SEQUOYAH NUCLEAR PLANT (SQN) - UNITS 1 AND 2 - RESPONSE TO REQUEST FOR ADDITIONAL INFORMATION ON THE INDIVIDUAL PLANT EXAMINATION OF EXTERNAL EVENTS (IPEEE) (TAC NOS. M83674 and M83675)

TENNESSEE VALLEY AUTHORITY
SEQUOYAH NUCLEAR PLANT (SQN)
UNITS 1 AND 2

RESPONSE TO SUPPLEMENTAL REQUEST FOR ADDITIONAL INFORMATION
SEQUOYAH NUCLEAR PLANT (SQN) IPEEE SUBMITTAL

Figure 3.1.3-12: Comparison of CR-0098 Rock Target Mean + one Standard Deviation Spectra to that generated for the 30 Time Histories: Sequoyah Nuclear Power Station, Component 2

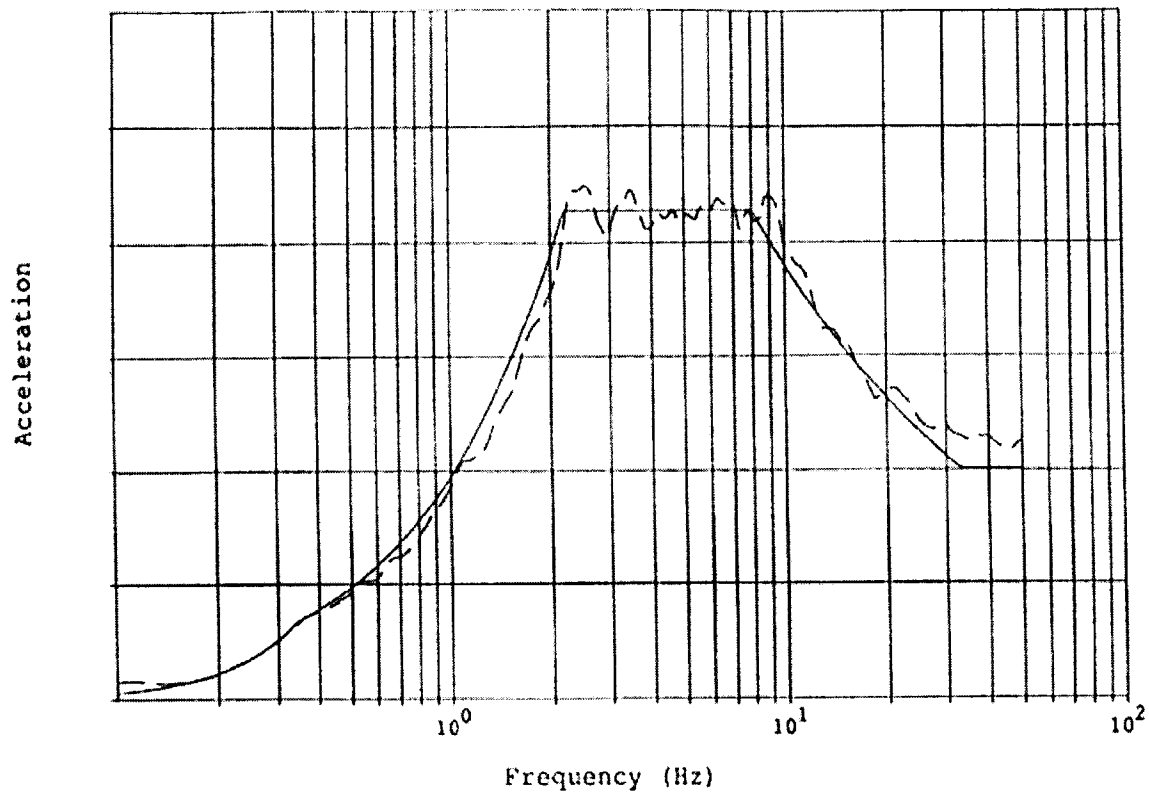
In the SQN IPEEE, the review level earthquake (RLE) was characterized in a manner inconsistent with the intent of NUREG-1407. The intent of NUREG-1407 is that the RLE control motion for SQN (which is predominantly a rock site) should be specified at rock outcrop as the NUREG/CR-0098 median 5% damped spectral shape for rock, anchored to a PGA of 0.30g at rock outcrop. The SQN IPEEE appropriately specified the RLE spectral shape as the NUREG/CR-0098 median rock spectrum at rock outcrop, but inappropriately specified the RLE PGA of 0.30g as occurring at the soil surface. Since this split approach of specifying the control motion has resulted in a rock outcrop peak ground acceleration (PGA) of about 0.19g, rather that 0.30g, the RLE seismic demands may have been considerably underestimated. The correct RLE demands may potentially be a factor of 1.58 (i.e., the ratio of 0.30 to 0.19) times those determined in the SQN IPEEE. [Stated differently, actual component capacities may be only about 0.63 (i.e., the ratio of 0.19 to 0.30) times the capacities computed in the SQN IPEEE.] Hence, components having computed high confidence of low probability of failure (HCLPF) capacities as high as 0.47g in the SQN IPEEE may have actual HCLPF capacities less than 0.30g.

In addition to the residual heat removal heat exchangers and essential raw cooling water 480V motor control centers that were found in the SQN IPEEE to have HCLPF capacities less that 0.3g, Table 3.1.4-1 of the SQN IPEEE submittal identified 14 items having HCLPF capacities less that 0.40g, and 43 additional items that were not screened out. These findings were based on the RLE demands as discussed above. If appropriate RLE seismic demands were applied, it is expected that additional components would not be screened out, the unscreened components would be assessed as having lower capacities, and several additional components would be identified as not meeting the RLE. For example, the following seven components were found from Table 3.1.4-1 of the SQN IPEEE submittal to have (or potentially have) a HCLPF capacity only slightly greater than the RLE.

Additional studies found in SQN IPEEE Calculation SCG-5M-0004, "Top of Soil Response Spectra at the Auxiliary Control Building Location" showed that further time history scaling was needed to provide 84th percentile nonexceedance probability (NEP) responses at top of soil in the vicinity of the Auxiliary Control Building (ACB). The final scaling of the three ensembles yielded 84th percentile NEP values of PGA for Components 1, 2, and 3 (i.e., Directions 1, 2, and 3) of approximately 0.22g, 0.235g, and 0.23g, respectively, rather than the target anchor value of 0.19g.

This conservatism in the PGA level in the ensemble time histories is qualitatively illustrated in Figure 3.1.3-12 (copy attached) of the IPEEE submittal. Therefore, the most appropriate factor for converting the HCLPF values presented in the IPEEE submittal to comparable values for an RLE anchored to 0.30g at rock would be the average PGA for the three components; or a conversion factor of 1.33.
